10 CFR 50.59 SUMMARY REPORT

<u>6</u> (Page 8.3-13)

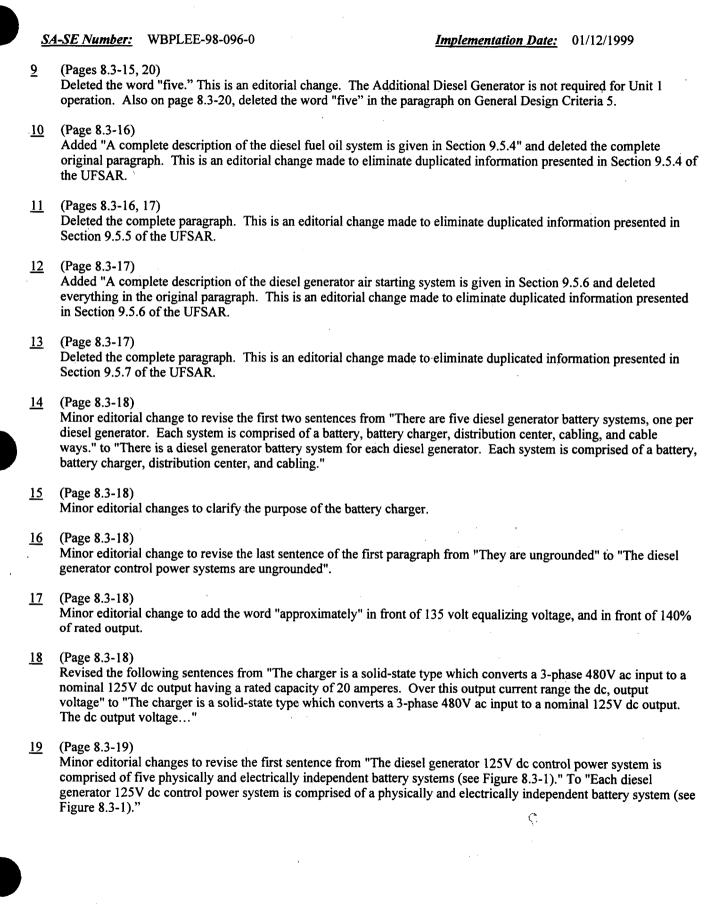
Deleted "Internal combustion engines operate most reliably at the rating for which they are designed. At extended light load operation, lube oil can be expected to accumulate in the exhaust system." This is a non-significant editorial change.
